## Technical Service Information Bulletin

# Title: **A/C BLOWER MOTOR MALFUNCTION** Models: **'97 ES 300**

AC002-98

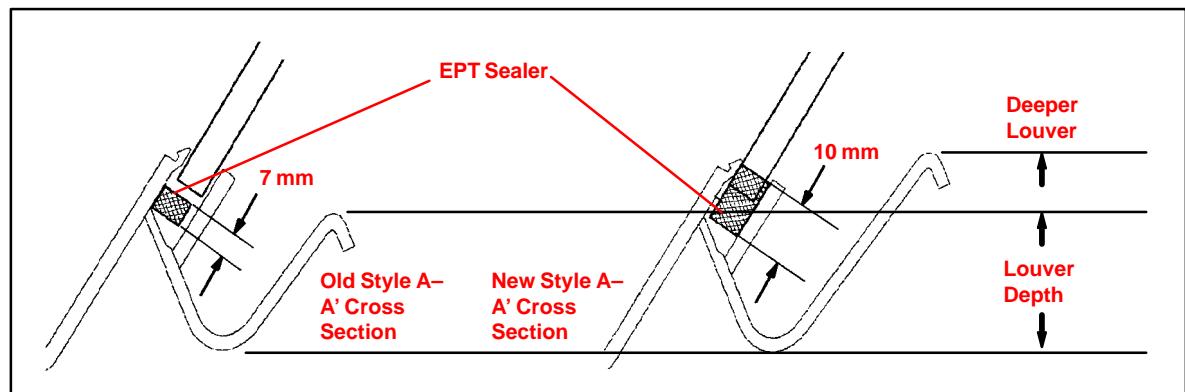
**Introduction** A Malfunction of the A/C blower motor may be caused by water intrusion into the blower unit due to a poor seal between the windshield and the cowl top ventilation louver.

To prevent this, the amount of caulking sponge sealant (EPT Sealer) applied behind the cowl top ventilation louver has been increased. In addition, the shape of the louver has been changed as shown in the illustrations below.

**Repair Procedure** If evidence of water intrusion into the blower motor housing is found such as rusting of the Blower Motor, perform the following operations:

1. Replace the Blower Motor (Refer to the Repair Manual for procedure).
2. Remove wiper arms and the hood to cowl top seal.
3. Replace the cowl top ventilator louver with new part.
4. Reinstall components in reverse order.
